**ISSUE:** Permit to Demolish/Capsulate (partial) and Certificate of Appropriateness for alterations and an addition

**APPLICANT:** Sharon Dow and Louis Alefantis

**LOCATION:** Old and Historic Alexandria District  
114 Princess Street

**BAR#2024-00404 & BAR#2024-00405**  
**114 Princess St**

Figure 2. Proposed north elevation.

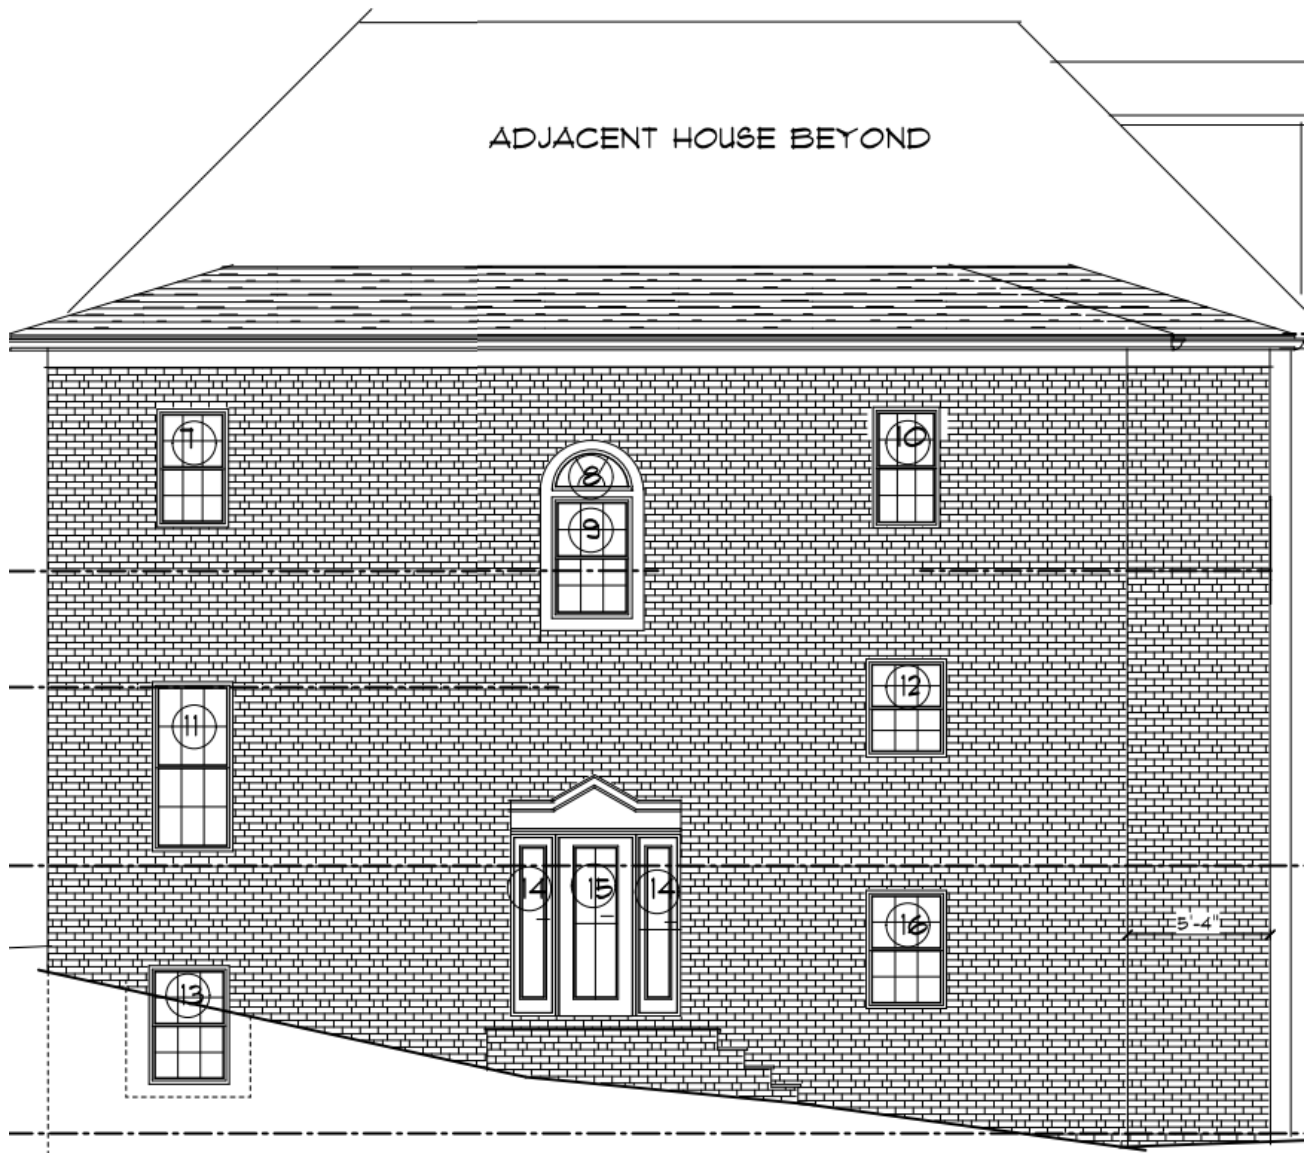
1. The masonry is stained or limewashed/whitewashed rather than painted.
2. The deck/trim of the proposed third-floor balcony on the north elevation is made of wood or metal.
3. The proposed windows are full-frame replacements rather than insert windows.
4. Work with staff to revise/simplify the composition of the windows on the east elevation.
